Department of Toxic Substances Control

May 26, 2010

The Department of Toxic Substances Control (DTSC) received the *Final Phase I Groundwater Sampling Field Sampling Workplan; Appendix A, Quality Assurance Project Plan; and Appendix B, Health and Safety Plan, University of California, Berkeley, Richmond Field Station*. The plans, all dated April 15, 2010, were prepared by Tetra Tech EM Inc., on behalf of the University of California. The plans describe the approach to investigate the shallow and intermediate groundwater zones found at the Richmond Field Station. This workplan represents the sampling strategy for Phase I. Additional phases are planned to complete the investigation and characterization of the site. DTSC program and support staff has completed their reviewed of the workplan and appendices. The workplan and appendices are approved contingent upon revision and deletion of the following items:

FIGURE 5
ECOLOGICAL
CONCEPTUAL SITE MODEL

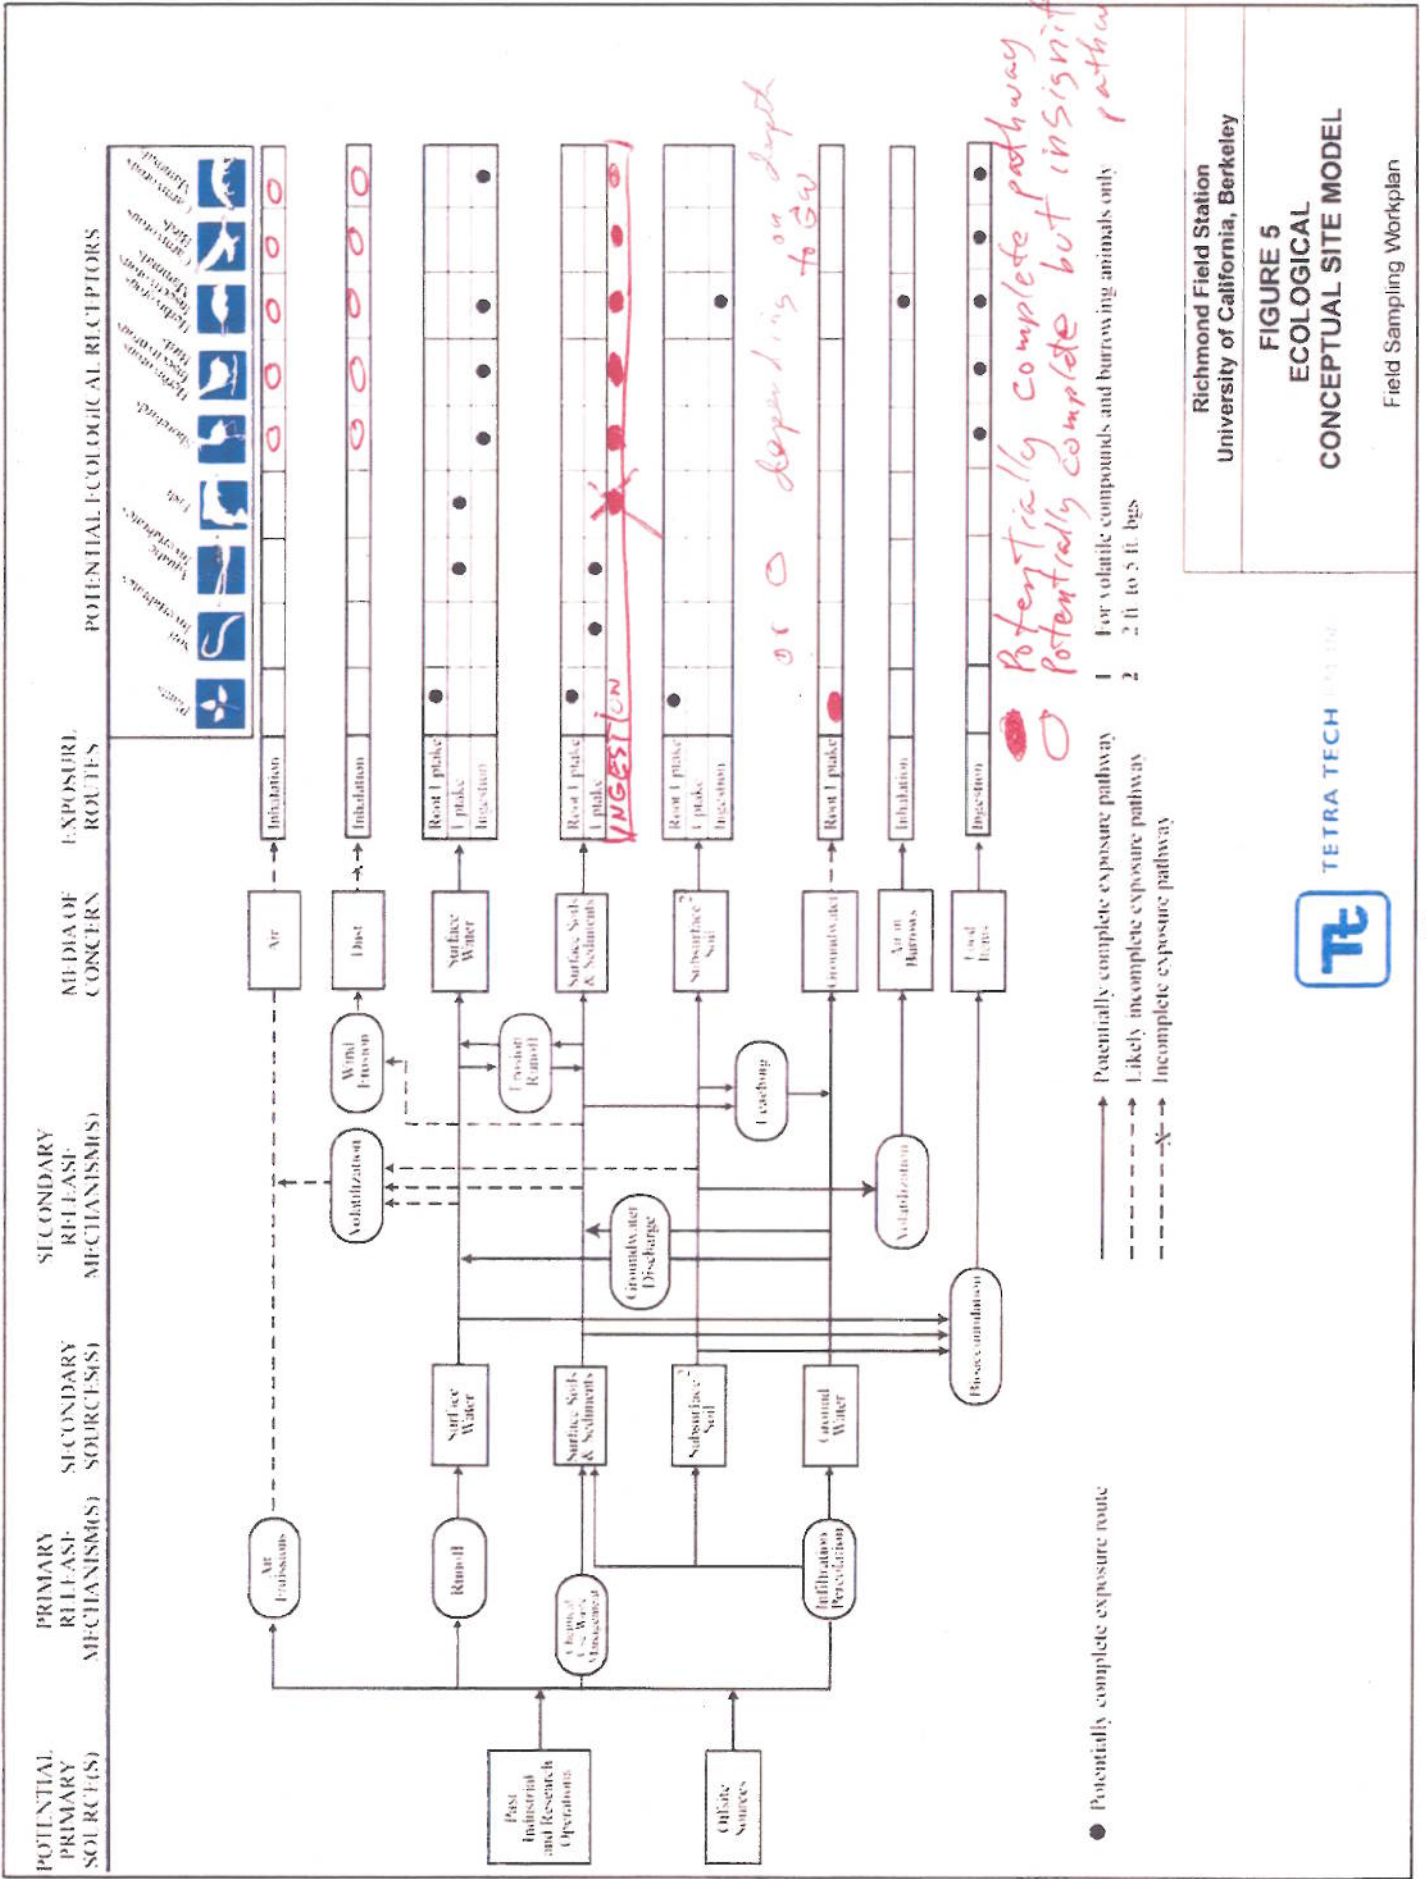
1. Figure 4, Human Health Conceptual Site Model: Footnote 1 is indicated at the bottom of the figure while no footnote is included on the chart. Either include the footnote on the chart or delete the footnote from the bottom of the figure.
2. Figure 5 Ecological Conceptual Site Model: This figure needs to be revised to include additional exposure routes and potentially complete pathways. A copy of the model with the additions is enclosed.
3. Page 17, Potential Exposure to Ecological Receptors: The second sentence in this paragraph needs to be revised to state that "Grasses, shrubs, and trees could be exposed to contaminants by taking up contaminants from soil and sediments."
